Product/Process Change Notice (PCN)

PCN Number: PCN_PeBU CF_20250618

Affected Series: WP-BUCF

Affected Part Number: 7460408 ; 7461086

- Pictures & dimensions

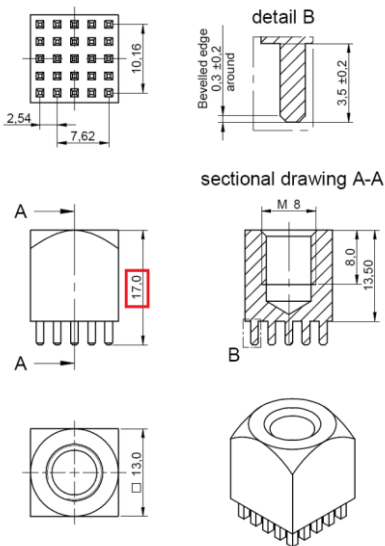
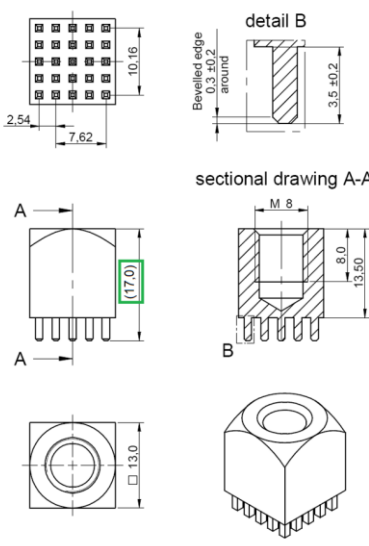
Due to an improvement of the production capability, Würth Elektronik eiSos will change the packaging from carton case to carton tray. The new carton will change the "single packaging quantity" (SPQ) and the "carton packaging quantity" (CPQ). The data sheet will be adjusted accordingly due to a technical, dimensional correction.

Before Change		After Change	
Carton Case (SPQ)	Shipping Carton (CPQ)	Carton Tray (SPQ)	Shipping Carton (CPQ)

Dimensions (LxWxH):	Dimensions (LxWxH):	Dimensions (LxWxH):	Dimensions (LxWxH):
108.0 x 85.0 x 65.0 mm	300.0 x 200.0 x 115.0 mm	274.0 x 171.0 x 15.0 mm	300.0 x 200.0 x min. 115.0 mm Height varies depending on the component due to two-part carton.
